Project	<b>IEEE 802.16 Broadband Wireless Access Working Group</b> < <a href="http://ieee802.org/16">http://ieee802.org/16</a> >	
Title	<b>Sleep Mode Operations for distributed scheduling in MR Network</b>	
Date Submitted	<b>2007-03-<del>1501</del></b>	
Source(s)	Qu Hongyun, Sean Cai, Mary Chion, Liu Yang, Chen Yuqin ZTE Corporation 712/2, Liantang Pengji Industrial Park, Luohu District, Shenzhen, P.R.China 518004	Voice:+86-755-26773000 exd. 6614 Fax:+86-755-26773000 exd. E-mail: <a href="mailto:qu.hongyun@zte.com.cn">qu.hongyun@zte.com.cn</a> , <a href="mailto:scai@zteusa.com">scai@zteusa.com</a>
Re:	IEEE 802.16j-07/007r2:“Call for Technical comments and contributions regarding IEEE Project P802.16j”	
Abstract	This document presents sleep mode operations for IEEE 802.16j. The existing IEEE 802.16e messages are reused and new parameters are introduced in order to facilitate the sleep mode management in IEEE 802.16j.

## Sleep Mode Operations in MR Network

**Figure 201 – Acknowledgement Header**

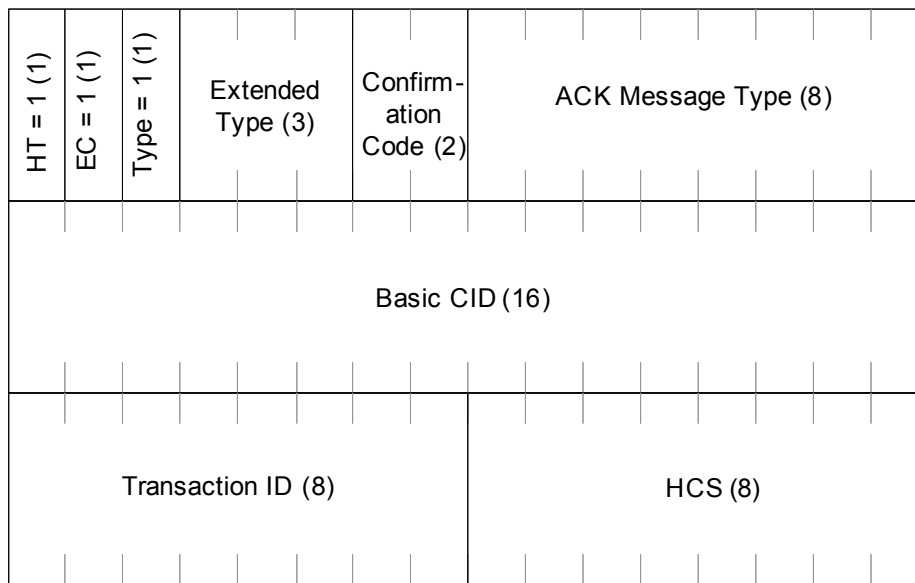
An Acknowledgement Header is sent by an RS as a response to a MAC management messages received from the MR-BS or its superordinate RS that requires acknowledgement. The RS sends this header to the MR-BS or its superordinate RS as an indication of the message reception. The Acknowledgement Header shall be sent on RS's basic CID. The Acknowledgement Header is illustrated in Figure 201.

The Acknowledgement header shall have the following properties:

- a. This is a MAC signaling header type II. The length of the header shall always be 6 bytes.
- b. The Type field of this header shall be set to 1.
- c. The Extended Type field of this header shall be set to 0b011
- d. The content of the header is listed in table 7k.

Figure xxx – The procedure of sleep mode

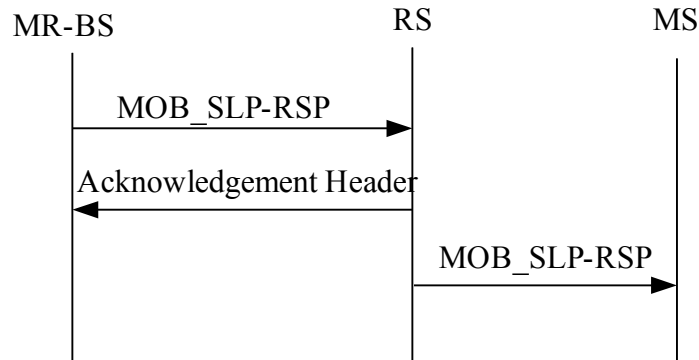
For an MS attached to the MR-BS through an RS with distributed scheduling, MS sleep mode operates as defined in section 6.3.21. All MOB\_SLP-REQ messages generated by MSs attached to an RS shall be relayed to the MR-BS. The MR-BS shall be responsible for generating MOB\_SLP-RSP messages, which will be relayed by RS, either in response to a MOB\_SLP-REQ or unsolicited. Upon receiving MOB\_SLP-RSP, the RS shall process and store the information contained in the message and send an Acknowledgement Header with ACK message Type set to 51 to MR-BS to indicate the reception of MOB\_SLP-RSP. The RS shall also relay MOB\_SLP-RSP to the MS(s). The MR-BS shall start timer T49 after transmitting a MOB\_SLP-RSP to the RS. If T49 timer expires before an Acknowledgement header is received, the MR-BS may retransmit an MOB\_SLP-RSP message to the RS. If duplicate MOB\_SLP-RSP message is received at the RS, the RS shall send an Acknowledgement Header to MR-BS without further relaying the message.

For multihop relay, after receiving the MOB\_SLP-RSP, the RS shall send an Acknowledgement Header to its superordinate RS to indicate the reception of message. The superordinate RS shall retransmit an MOB\_SLP-RSP message if it does not receive an Acknowledgement Header before T49 Timer expires. If duplicate

MOB\_SLP-RSP message is received at the RS, the RS shall send an Acknowledgement Header to its superordinate RS without further relaying to the message

Figure xxx illustrates the procedure of MR-BS during MS sleep mode.
